**Apex Energy**

**Supplementary Information**

# **Illawarra Coal Seam Gas Exploration Drilling and Gas Monitoring Program**

**Prepared by Olsen Consulting Group  
June 2009**

Figure 2. Original and New Location for AI05.

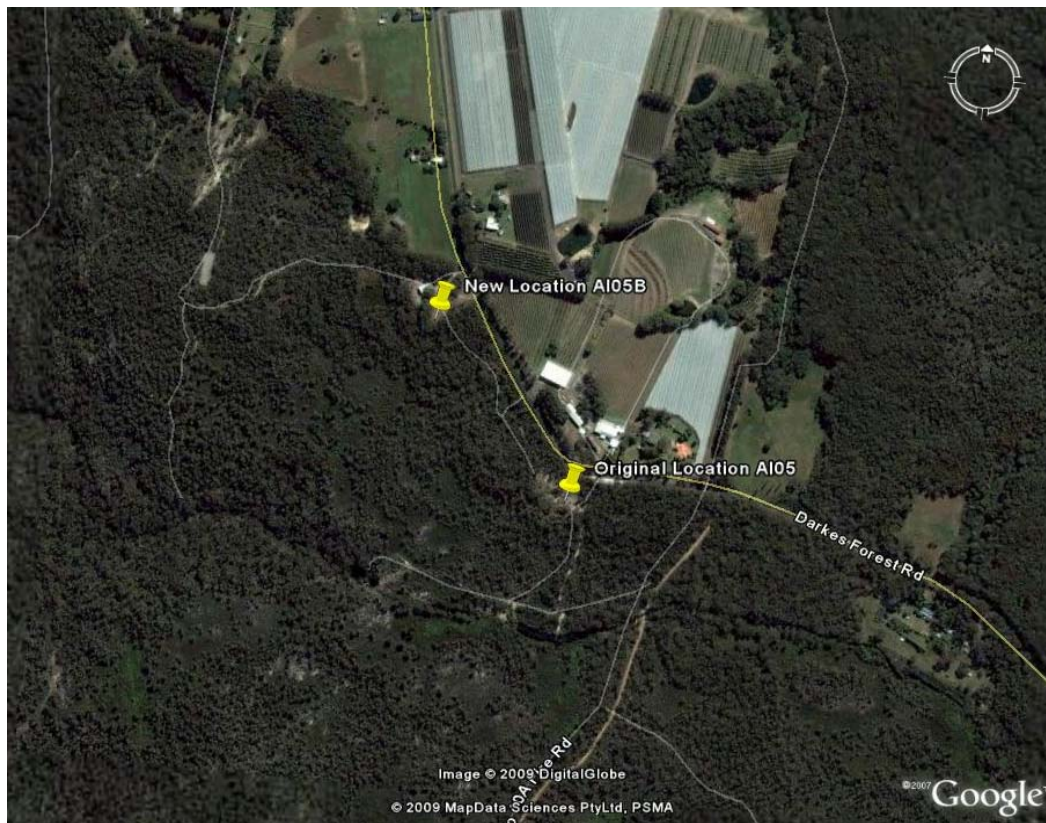
**Figure 2** is a Goggle Earth diagram showing the original location of AI05 and the proposed new location on the Rural Fire Services/Darkes Forest Community Hall site adjacent to Darkes Forest Road.

The National Parks and Wildlife Service (DECC) expressed concern about the original location of this borehole. The originally proposed site was an old gravel quarry that is in the process of rehabilitation including the provision of suitable habitat for frog species.

**Figure 2** shows three residences near the proposed new site. These are located 140 m to the northwest (304 Darkes Forest Road), 152 m northeast (311 Darkes Forest Road) and 230 m (313 Darkes Forest Road).

Apex has relocated AI05 onto Crown Land adjacent to the Darkes Forest Rural Fire Station and the Drakes Forest Community Hall. The site was inspected during the original site inspections undertaken between 3<sup>rd</sup> and 5<sup>th</sup> September 2008 and was re-inspected on 4<sup>th</sup> June 2009.

This site is cleared of native vegetation and supports mown grass. The new site eliminates the need to clear native vegetation.

The site slopes at about 5 degrees to the south away from Darkes Forest Road. It is proposed to install suitable erosion and sediment control measures as described in the original Environmental Assessment.

Apex will implement the following noise abatement measures to manage potential acoustic impact at these residences.

Figure 4. Original and New Location Borehole AI10

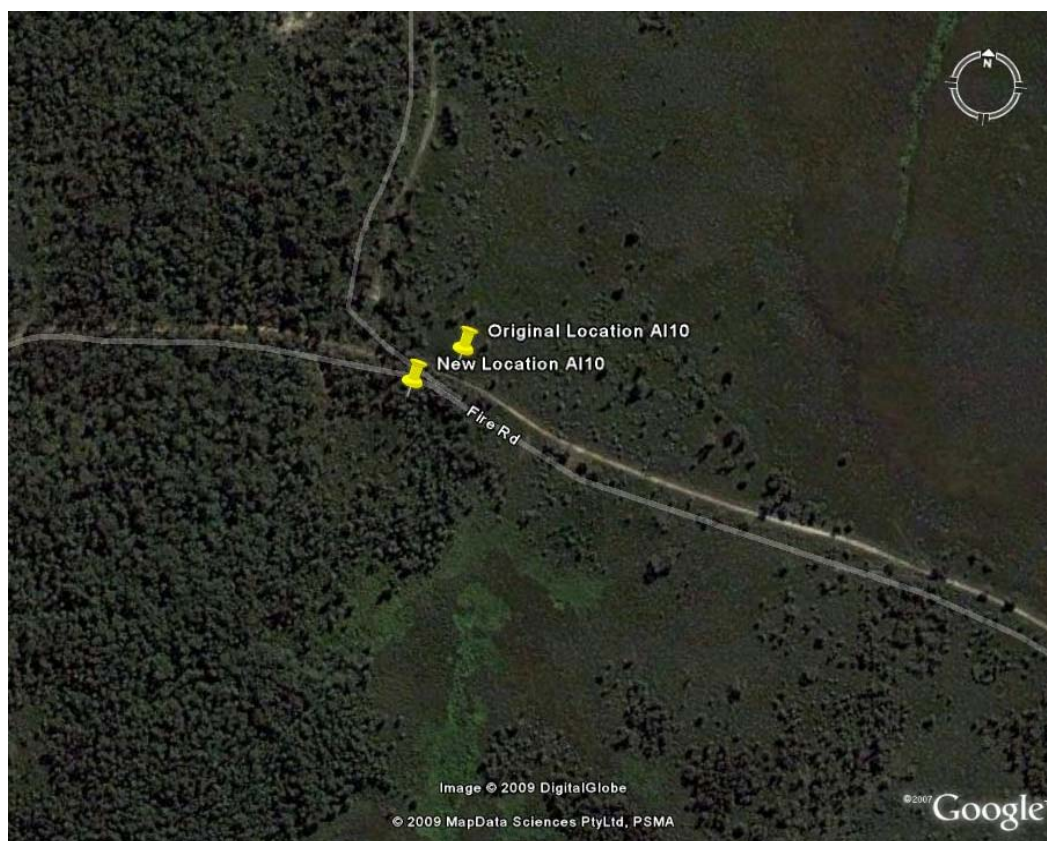
**Figure 4** is also a Goggle Earth diagram showing the proposed new location of AI10. This borehole has been moved only a small distance (approximately 40 m), however, it is relocated off Upland Swamp vegetation community.

The original location for AI10 impacted a section of the Upland Swamp vegetation community. A number of submissions requested that disturbance to this community should be avoided or minimised.

During the inspection, Apex decided to relocate AI10 approximately 40m south southwest of the original location. The new location is on the southern side of a fire track and is located on an area of land that does not support Upland Swamp vegetation. The original and new locations of Borehole AI10 are shown on **Figures 4 and 5**.

Figure 5. Detail of New Location of Borehole AI10

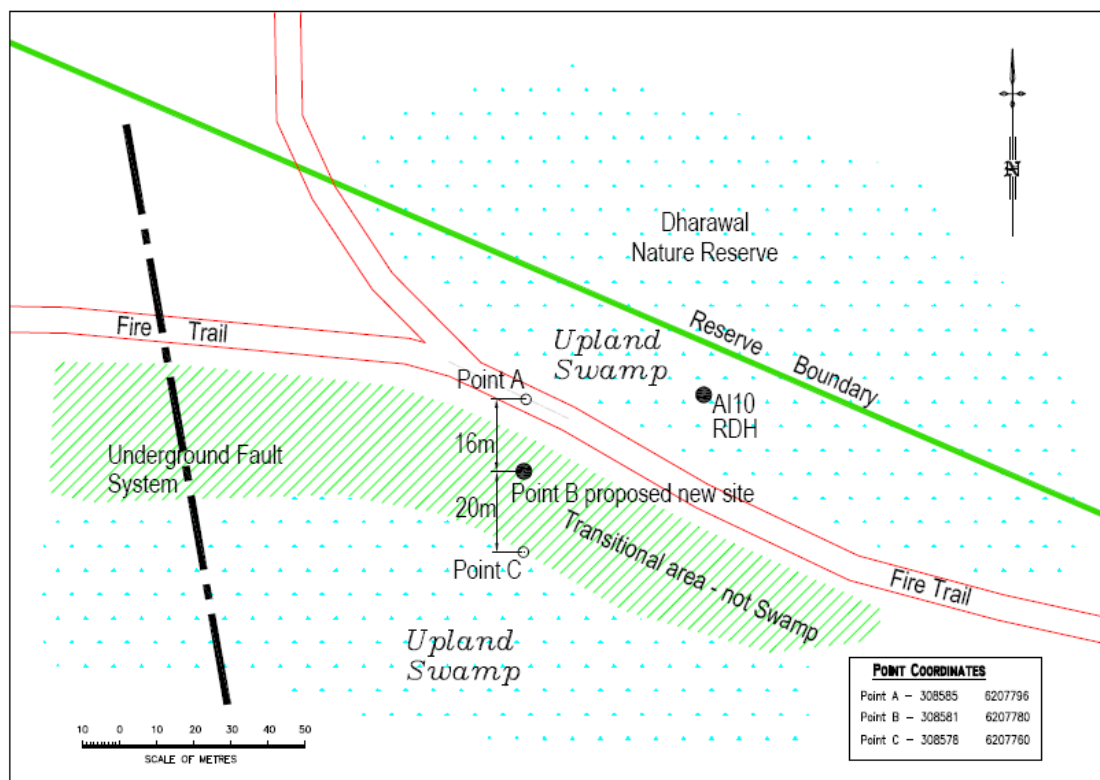
**Figure 5** shows more detail of the original and new site for AI10.

Appropriate erosion and sediment control structures can be installed at the new site and no Upland Swamp vegetation will be cleared during the proposed drilling.
